Landmarks Commission
Meeting of June 1, 2020
Legistar 59708, Agenda item #1, 817-821 Williamson St.

The undersigned seventeen residents of the Marquette neighborhood urge the Landmarks Commission to **deny the applicant's request** for a Certificate of Appropriateness for construction of a new principal structure in the Third Lake Ridge Historic District.

Page 17 of 5/8 submission

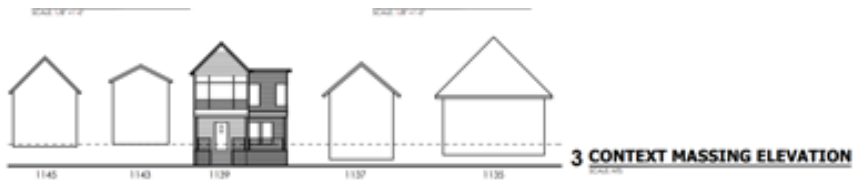
Pages 17-19 of the applicant's submission provide a sense of how the proposed structure would dominate the block. However, the angles used in these renderings can be misleading.

- Page 1 of Attachment B shows the view looking east. The applicant's rendering of the house on the right faces west (one can see the east side of the porch steps), yet one can also see the west side of the proposed building – a view that is not possible with only a 12 foot gap between the buildings. And the house appears much closer to the sidewalk in the applicant's renderings.
- Page 2 of Attachment B is the view looking west. Of particular note is the massive size of 831's back warehouse as compared to the Goggle view. Or look at the steps of 813 on page 2 – the entire set of steps is visible despite the steps being set back about 8 feet from the sidewalk.
